DEVELOPMENT REVIEW COMMITTEE (DRC) COMMENT REPORT

PROJECT NAME: Riva Condominium Boat Lift

CASE NUMBER: PLN-SITE-20030011

REQUEST: Site Plan Level II - One Additional Boat Lift

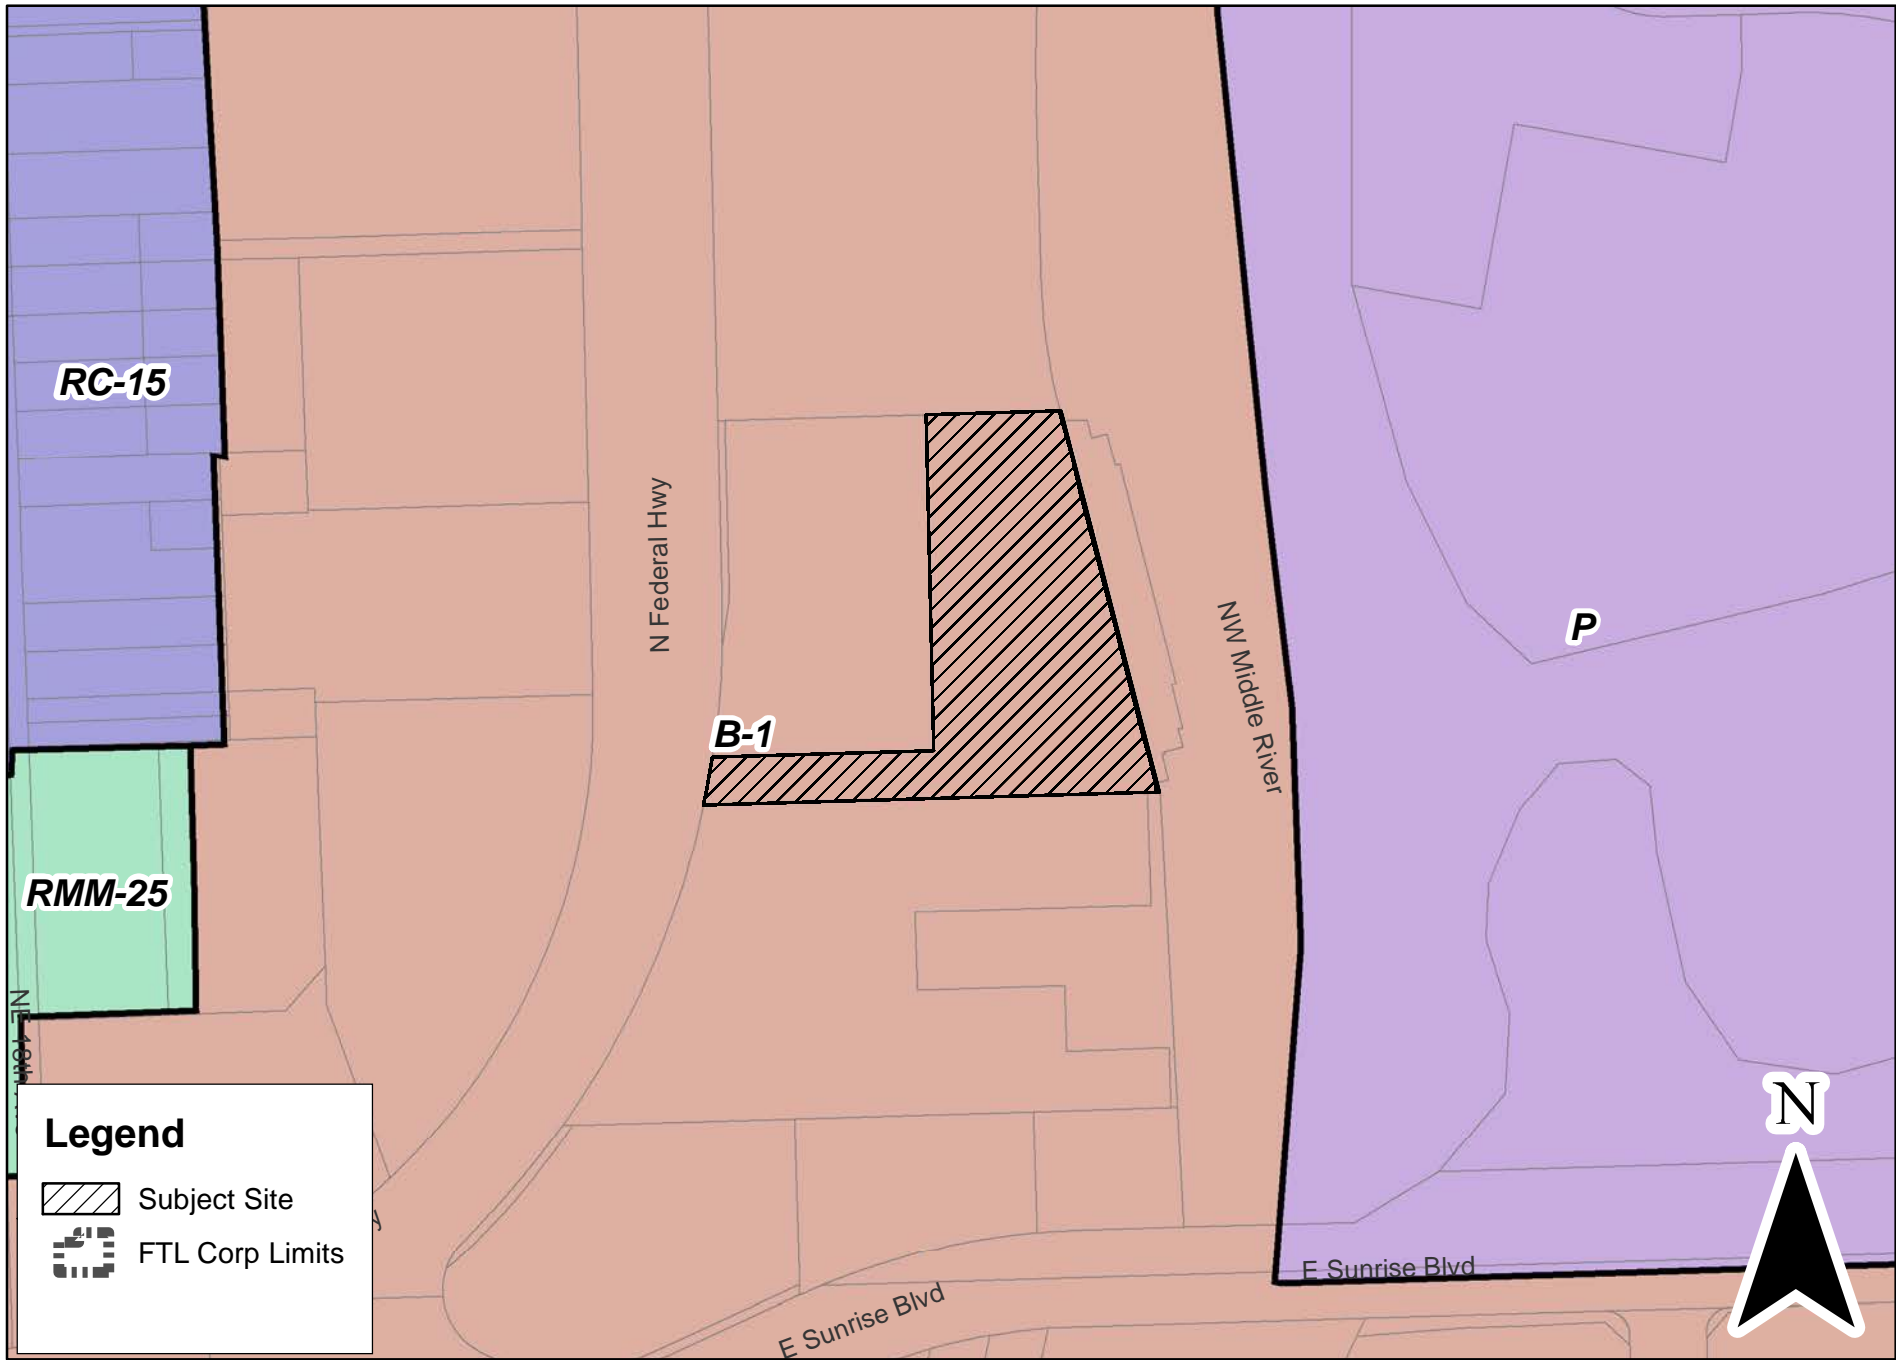
- 5) Clarify proposed height in the site data chart on Figure 3: Cross Section of Proposed Boat Lift and show visually depict the setback dimensions from the wetface of the seawall.
